Instrument Engineering Change Notice

NO. VIP6AI-2001

| PRODUCT NAME | : Tissue-Tek VIP6 AI | DATE | : March 18, 2020 |

Title: Software and Hardware Changes for New CI

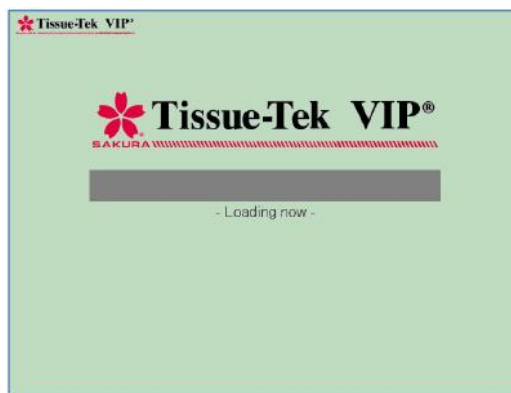
(1) The logo displayed at the top left corner of each operation screen was deleted due to the change to the new CI.

The loading screen was also changed with the change of the initial program loader, as follows:

New loading screen (white background)

Old loading screen

New operation screen

Old operation screen
